**Planned Unit Development (PUD)—
Brixmor Property Group, LLC**

RECOMMENDATION REPORT

CASE NUMBER: PPUD-19-0002

RE: Planned Unit Development (PUD) Amendment
Initial Review
Brixmor North – Southport West

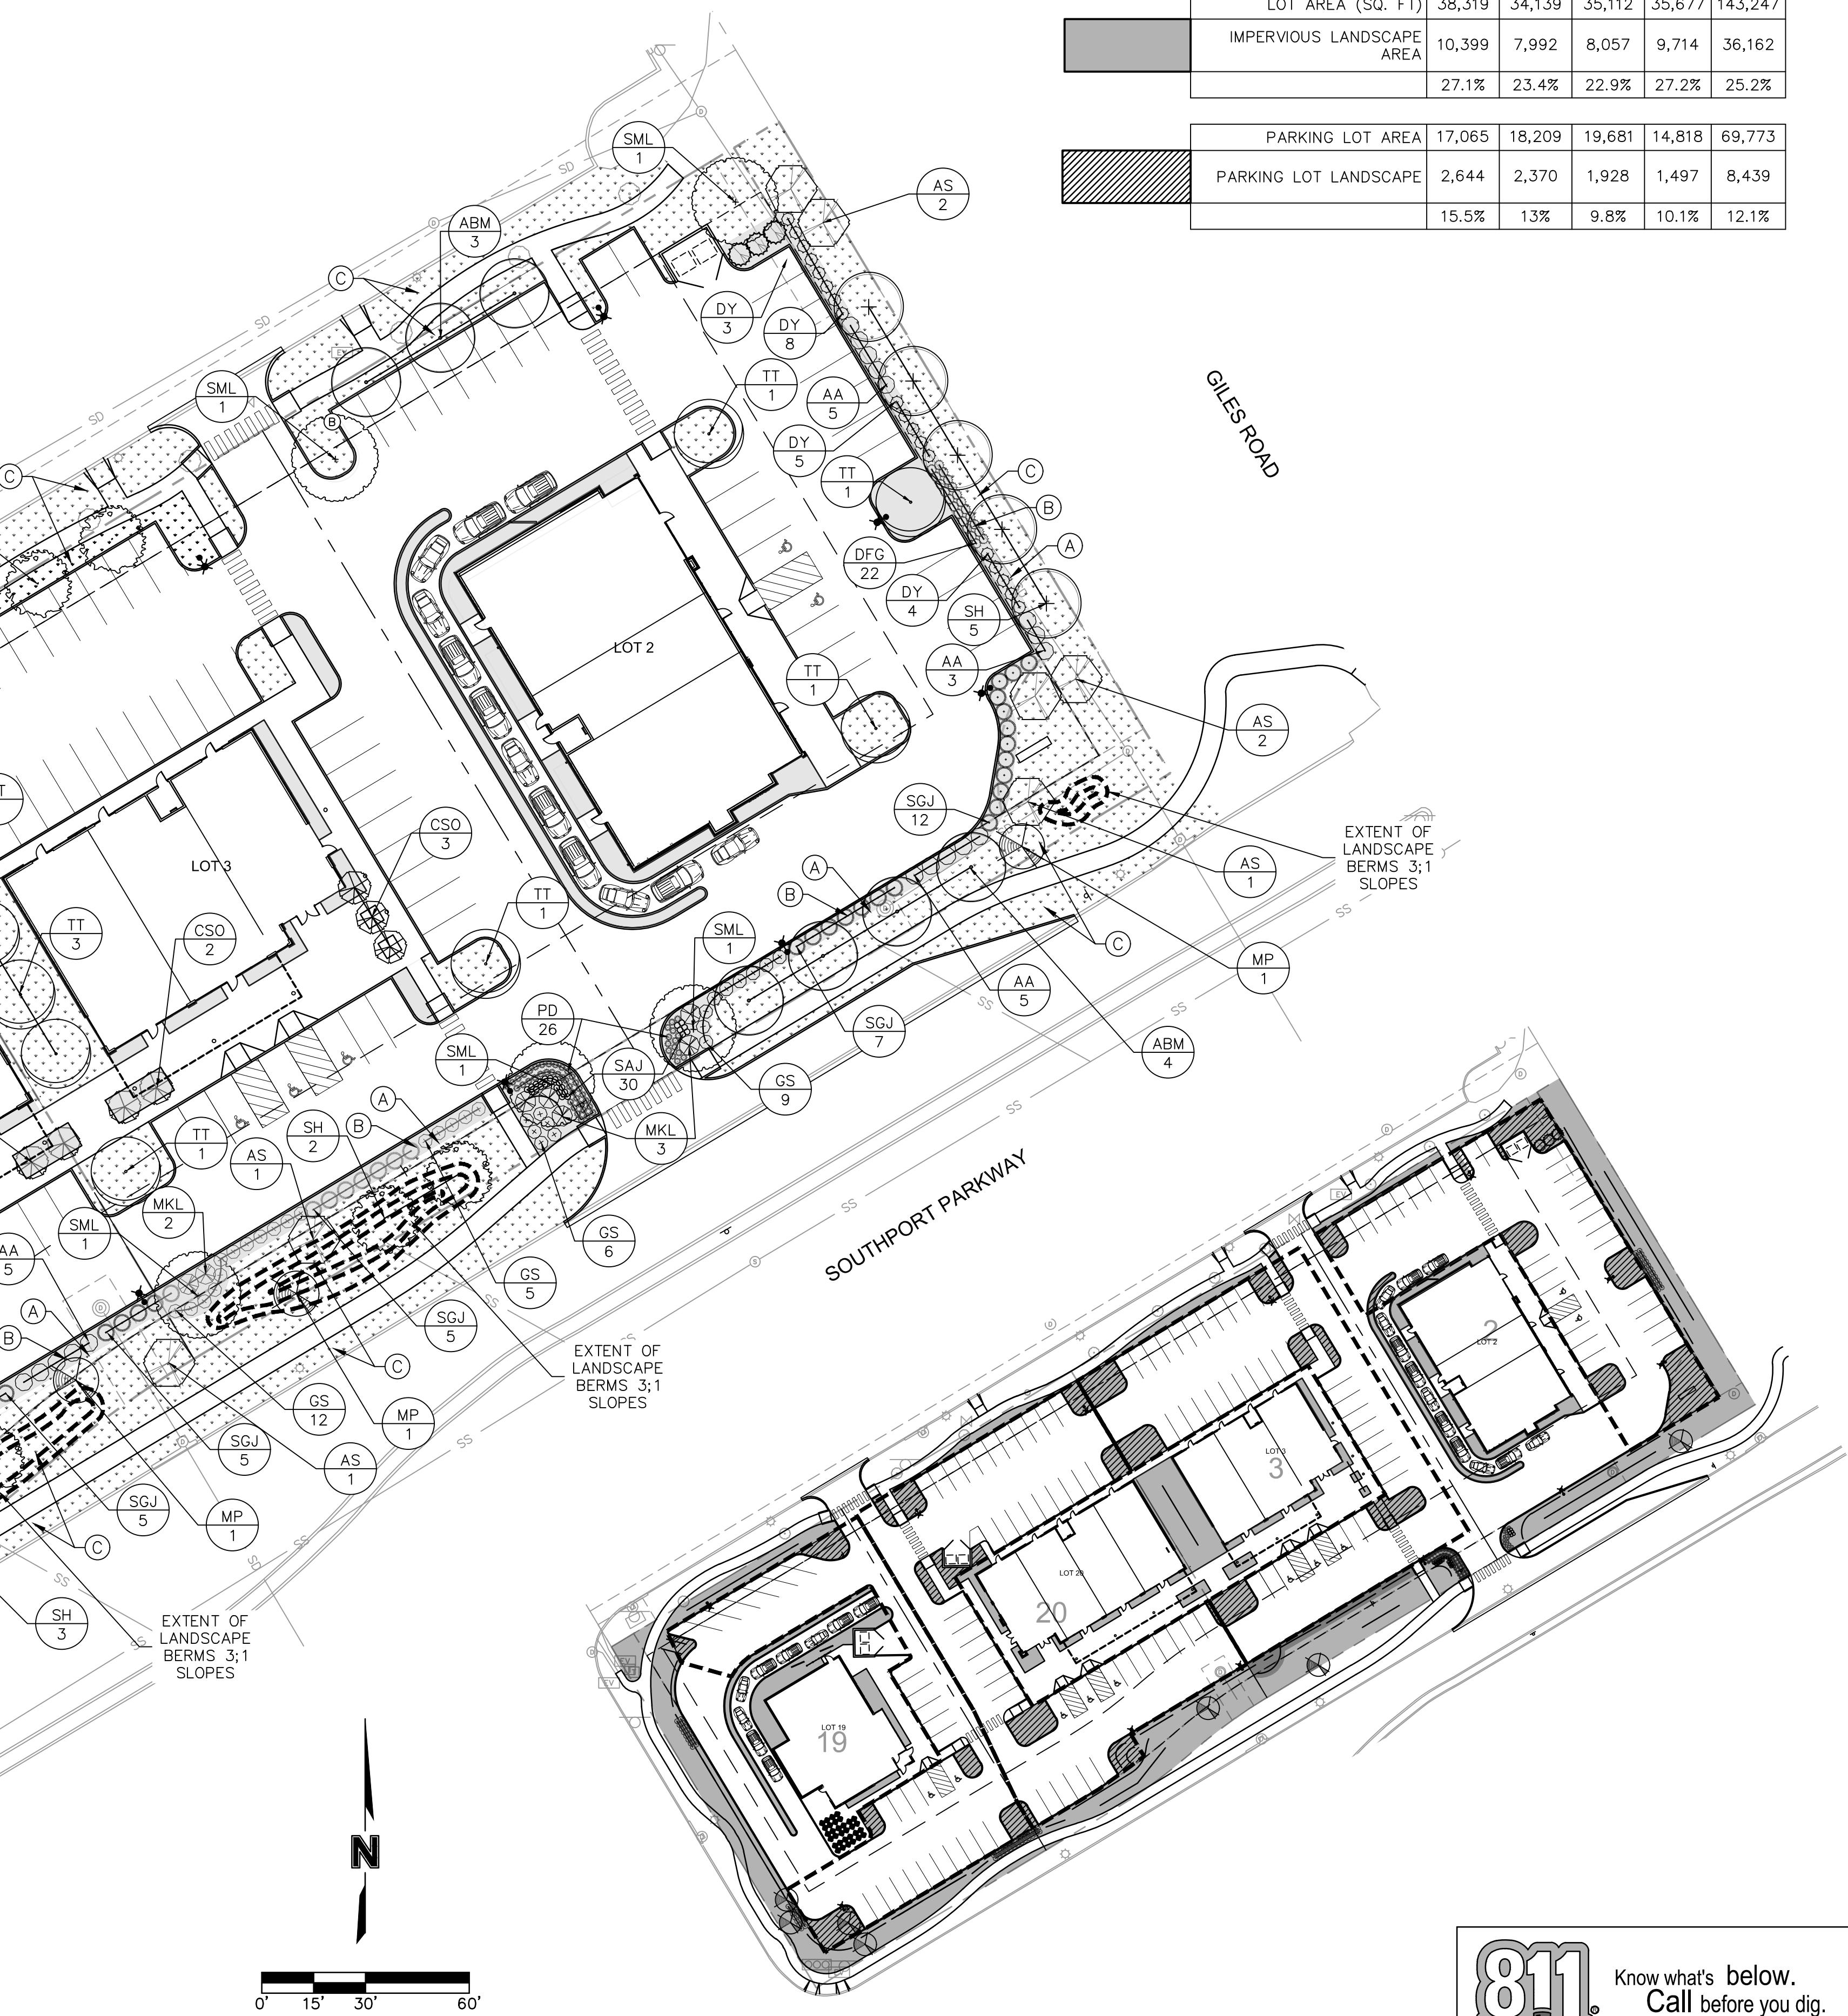
Landscaping Sheet

- Ordinance 1267 requires each lot to have 25% of each lot as open space and parking areas to include green space equal to at least 10% of the total paved area. The Landscaping plan notes 27% greenspace of the total of the four lots. This area needs to be illustrated with hatching or shading. It does not appear that each lot would individually meet the 25%, therefore language may be needed to address this in the PUD Amendment. Data on the parking lot greenspace is needed.
- Confirm all landscaping/berm requirements are being met per current PUD, unless otherwise noted within a proposed PUD amendment.

Landscaping Sheet

- Ordinance 1267 requires each lot to have 25% of each lot as open space and parking areas to include green space equal to at least 10% of the total paved area. The Landscaping plan notes 27% greenspace of the total of the four lots. This area needs to be illustrated with hatching or shading. It does not appear that each lot would individually meet the 25%, therefore language may be needed to address this in the PUD Amendment. Data on the parking lot greenspace is needed. **Response: Landscaping Plans have been updated with the requested table.**
- Confirm all landscaping/berm requirements are being met per current PUD, unless otherwise noted within a proposed PUD amendment. **Response: Berms have been added along Westport Parkway and shrubs are provided along Southport for screening.**

Sheet L1.1

Landscaping Sheet

- Confirm all landscaping/berm requirements are being met per current PUD ordinance **Response: Landscaping Plans have been revised to add the requested berms coordinated with Civil sheets.**

Sheet L1.1

- Proposed berthing not in conformance with regulations. See comments regarding Sheet C3.1 for more information.
- The dumpster location in the northeast corner of the property needs to be moved away from the Giles Road frontage.

Sheet L1.1

- Proposed berthing not in conformance with regulations. See *comments* regarding Sheet C3.1 for more information. **Response: Berming has been revised to meet the requirements provided in Appendix C.**
- The dumpster location in the northeast corner of the property needs to be moved away from the Giles Road frontage. **Response: Dumpster has been relocated to the north parking area. This has been placed outside of the easement and the site plan has been updated.**

Figure 2. Existing Traffic Volumes

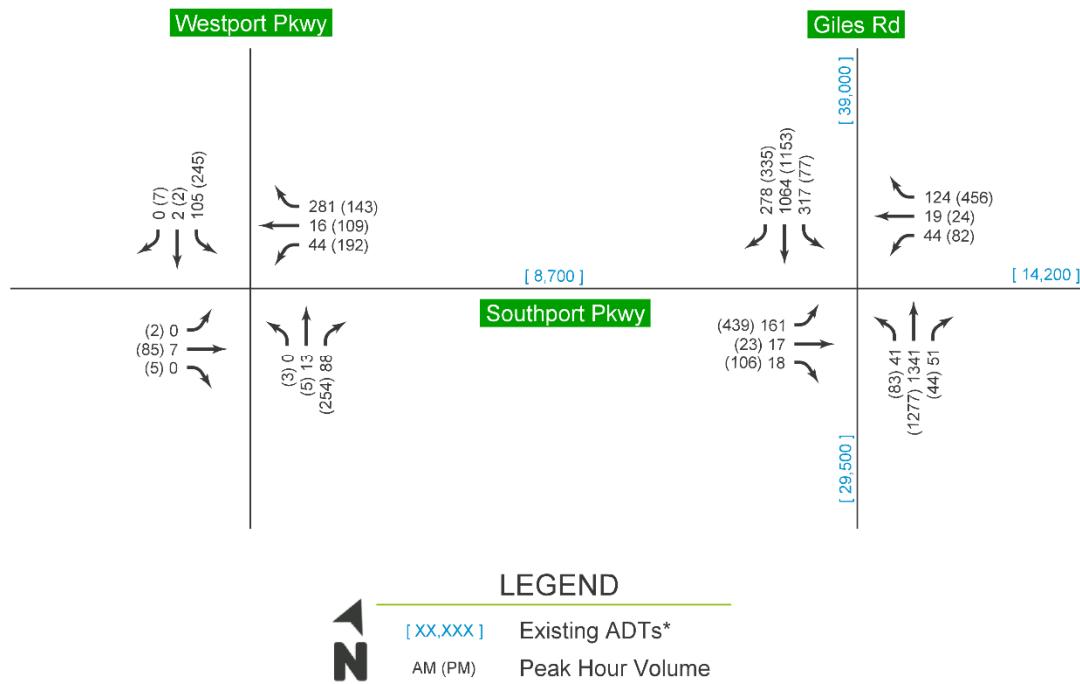
- Please note the source of Existing ADT values in Figure 2 of the study.
- Please provide total driveway volumes when considering both primary and pass-by trips.
- Trip distribution does not appear to fully take into account pass by trips to destinations within Southport development. Is there a standard methodology that is being used to apply the distribution percentages as applicable adjacent land uses/trip generators?

- Please note the source of Existing ADT values in Figure 2 of the study **Response:**
- Please provide total driveway volumes when considering both primary and pass-by trips. **Response:**
- AM signal timings should be reviewed to make recommendations as to any pertinent modifications **Response:**
- Applicant should install all access and signage improvements as recommended in Section 7 of the Traffic Impact Study **Response:**
